000			
	7 If Unit of CA. Agreement Designation ROSA		
1. Type of Well Oul Gas Well X Well	Other	8. Well Name and No. 82	
2. Name of Operator	MITCHELL ENERGY CORPORATION	9. AM Well No. 30-039-22667	
3. Address and Telephone No.	555 17th Street - Suite 3500 Denver, CO 80202 (303) 292-4455	10 Field and Pool. or Exploratory Area Basin Fruit land Coal	
4. Location of Well (Footage: Se	1850' FSL & 1550' FWL (NESW) Sec. 9-T31N-R4W	Rio Arriba, NM

ROSA UNIT NO. 82

Proposed Plug & Abandon Procedure

CONDITIONS OF APPROVAL

PROPOSED P & A SCHEMATIC

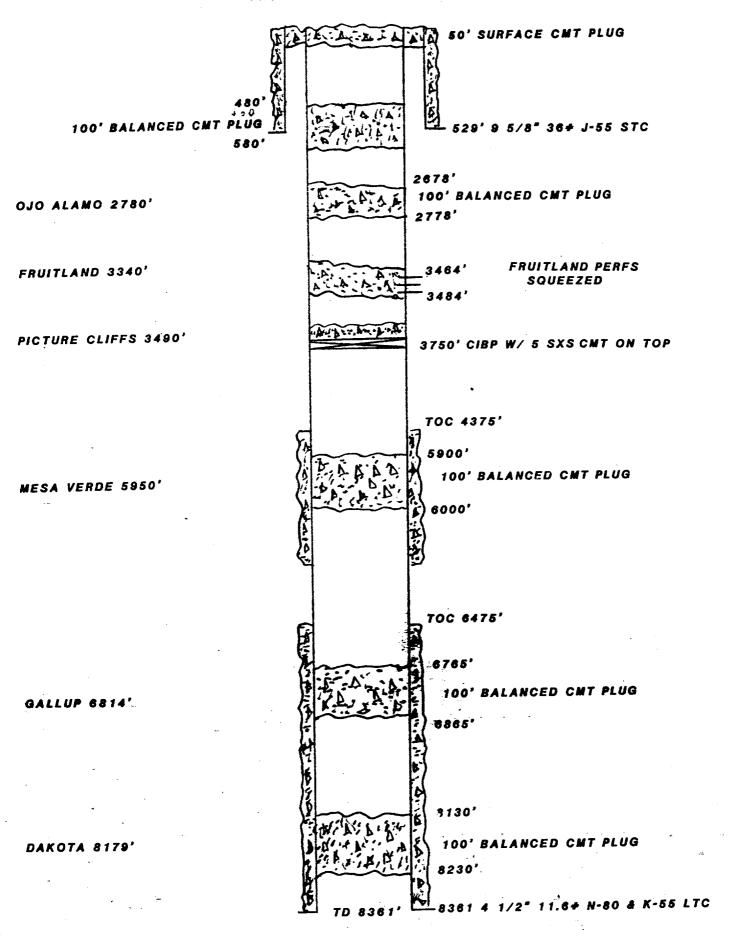
- 1. Plugging operations authorized are subject to the attached "General Requirements for Permanent Abandonment of Wells on Federal Leases."
 - with the Farmington Office is to be notified at least 24 hours before the plugging operations commence (505) 326-6201.
- ----3. Blowout prevention equipment is required.
 - 4. The following modifications to your plugging program are to be made (when mapplicable): 宮舎を表現できると
 - a) place the Gallup-pluy from 6754-6654 + 50% excess
 b) place the Messavede pluy from 5505-5404 + 50% excess
 - c) Bring the Fruitland play up to 3290' inside Lourside 4/2 essing
 - d) place Ojo Alimo ply from 2890 2790 inside Lourside 4/2"+100% excess
 e) place Svitace Cosing shoe from 580-480 inside Lourside 41/2"+100% excess
 - f) Surture plug is to be set inside doutside 4/2" (com
